145425

Item ID: D350-607-511 Accept *N900040100* Setup Start *NS1*
 Revision ID: Stop *NS2*
 Item Name: Quick Release Basket and Long Cargo Tube Mounting Provisions, Fits LH or RH
 Start Date: 4/27/2016 Start Qty: 2.00 *2* Cust Item ID:
 Required Date: 5/5/2016 Req'd Qty: 2.00 *2* Customer:
 Reference:

DART SERVICE INSTRUCTION

TO AMEND INSTALLATION INSTRUCTIONS D350-607-3 Rev.D,
INSTALLATION INSTRUCTIONS D350-607-4 Rev. C AND
INSTRUCTIONS FOR CONTINUED AIRWORTHINESS ICA-D350-607 REV. 6

FIGURE 1: INSTALLATION OF D4775-041 FWD STRUT

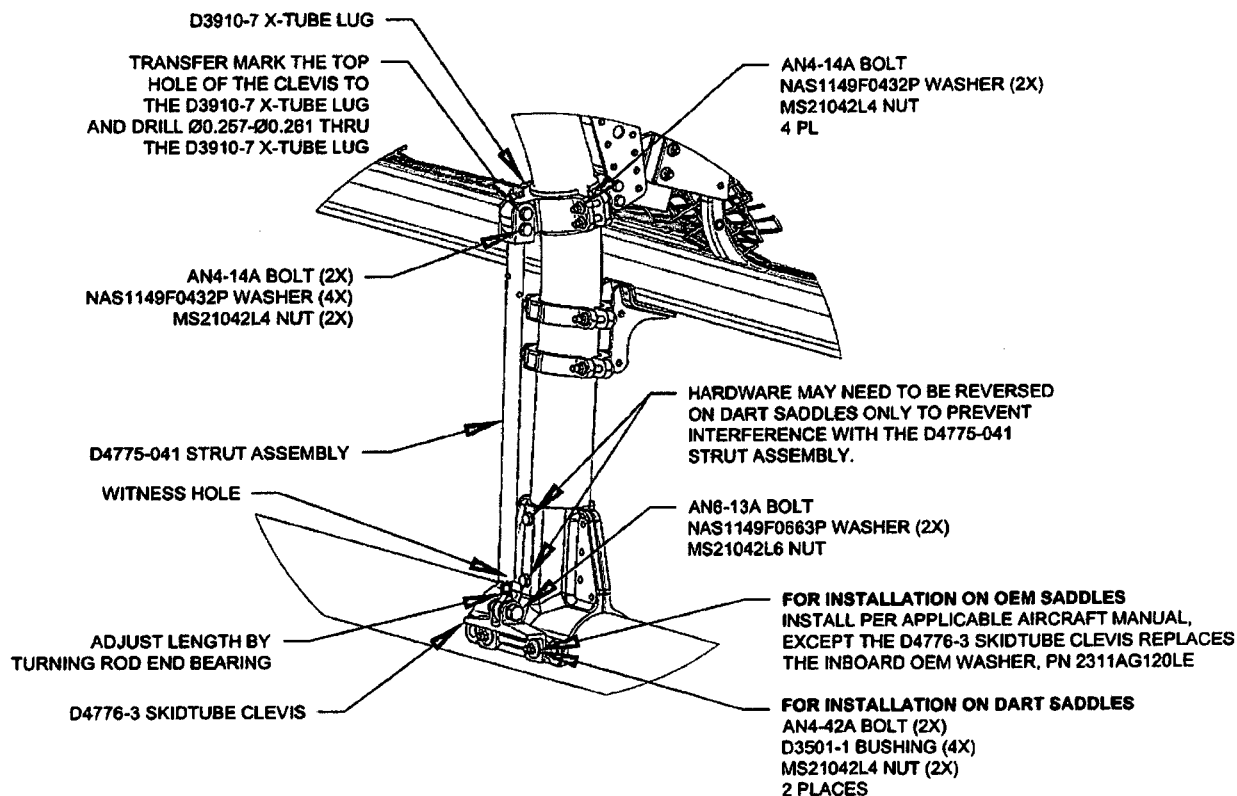
3.1 Substitute the Forward Lower D3910-5 X-Tube Lug with the D3910-7 X-Tube Lug as shown in Figure 1.

3.2 Install the forward D4775-041 Strut Assembly. Transfer mark from the upper hole on the clevis of the D4775-041 Strut Assembly to the D3910-7 X-tube Lug and drill thru the lug $\varnothing 0.257 - \varnothing 0.261$ as shown in Figure 1. Touch up chemical conversion coating per MIL-DTL-5541. Check the witness holes located at the bottom end of the D4775-041 Strut Assemblies to ensure that the thread from the rod end extends past the witness hole.
Torque MS21042L4/-4 nuts to 50-70 in-lbs (5.7-7.9 N-m). Torque MS21042L6/-6 nuts to 160-190 in-lbs (18.1-21.5 N-m).
